1. Section length- On the drawings, below note is mentioned-

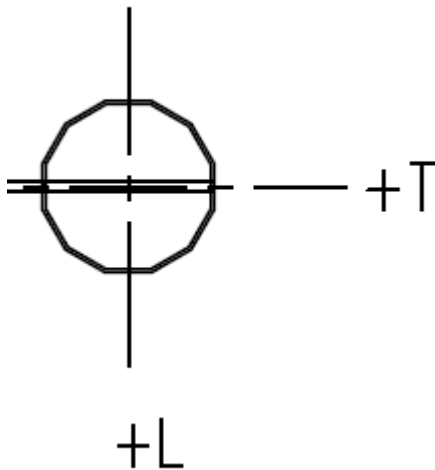
7. In page 32/63 Distribution arm detail is not specified. Assuming Detail "AR5.5D" for this.
Should be detail AR5.5D for arm detail on STR 23.
8. For few structures Distribution cross arm are by others for example in page 37/63 for which arm length is not available. Assuming 10ft for this for load offset purpose.
All Running angle structures have 12' crossarms
9. In page 40/63 all transverse loads are applied in -Ve direction as per the line angle irrespective of the load tree.
All point loads on the load tree should be as shown below, Positive down, Positive out of page, Positive right. Load directions in load table are correct.

Per PLS CADD default settings, Positive Longitudinal axis is always on back span face of pole and positive Transverse axis is always on the right side of the pole looking towards the ahead span.
